OCHC 214 Somerset

Design Brief

214 Somerset St. E., Ottawa, ON, K1N 6V4
CSV project # 2022-2471

Figure 6: Proposed Site Layout

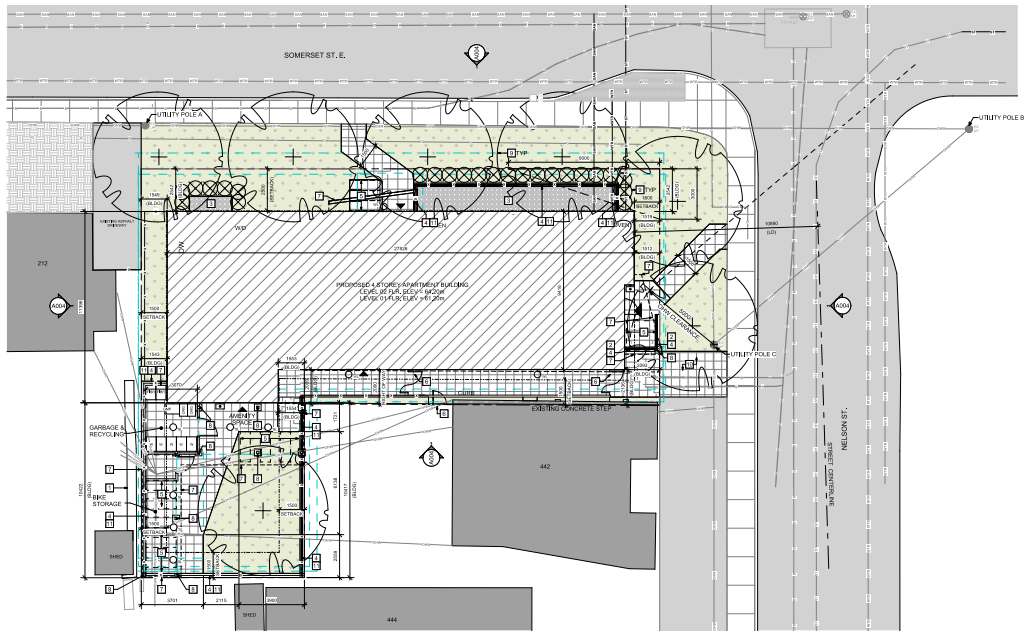
2. City Staff wanted to ensure that waste management was considered. They requested details of the garbage storage area as well as the path and staging area for the containers.

3. City Staff asked the team to consider a completely fenced rear yard with controlled access for safety purposes.

4. City Staff asked the team to show light fixtures on the initial plan.

Response: The garbage bins will be stored in the accessory structure located in the rear yard. This structure is located in the rear yard. It provides space for the following:

- 5 x 360L waste bins
- 2 x 360L fibre bins
- 2 x 57L organic bins
- 1 x 360L GMP bin

Response: This is provided in the design.

Response: These are indicated on the Site Plan provided.

Figure 7: Level 01 Floor Plan

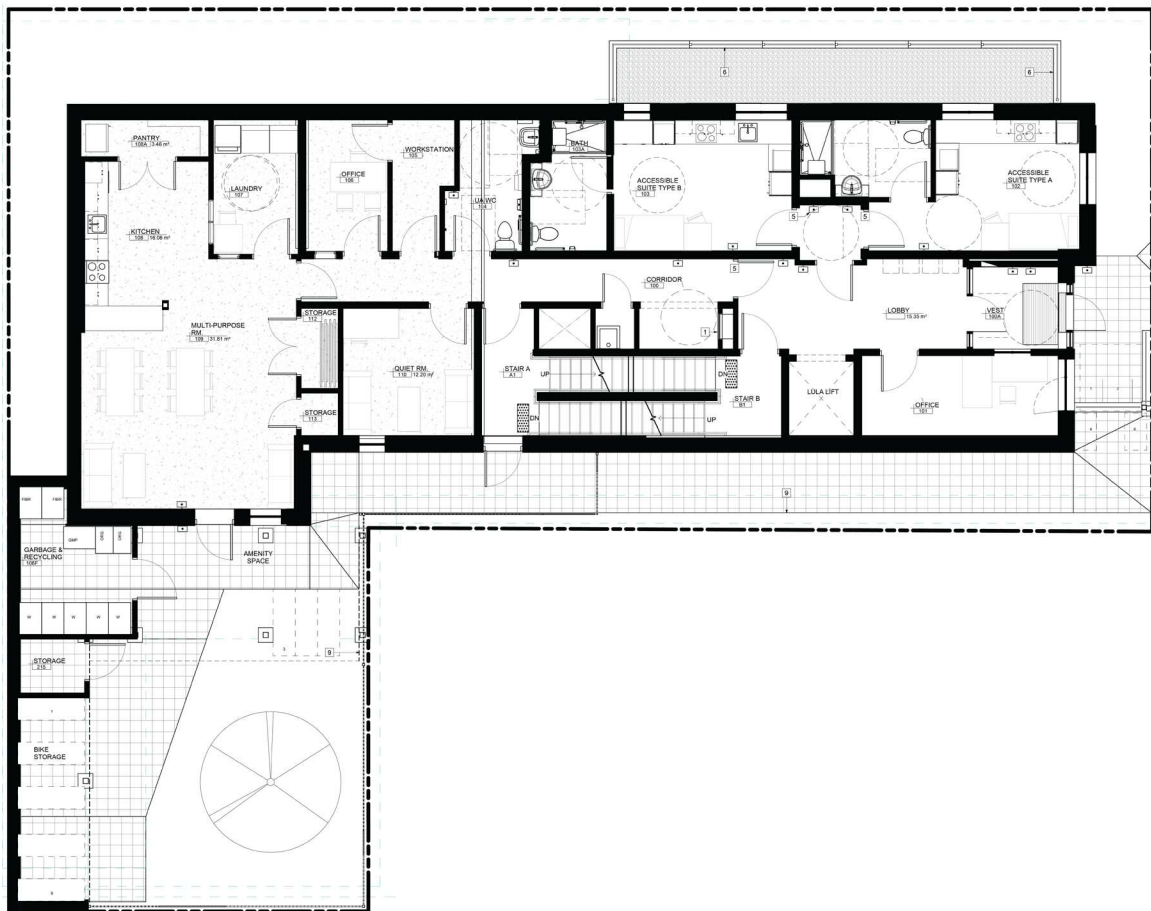
4. Ensure there is sufficient bike parking for the development

7. No automobile parking, or limited parking that is concealed from the street and not forming an integral part of a building such as in a front facing garage.	There is no automobile parking proposed. Bicycle parking spaces proposed are 174% of required with 20 spaces total. 12 spaces are provided in the rear yard (Figure 7), 3 at the Somerset St. entrance (Figure 8), and 5 at the Nelson St. entrance (Figure 7).

Response: 20 bicycle parking spaces are planned including 12 covered, 3 at the Somerset street entrance, and 5 at the Nelson street entrance.
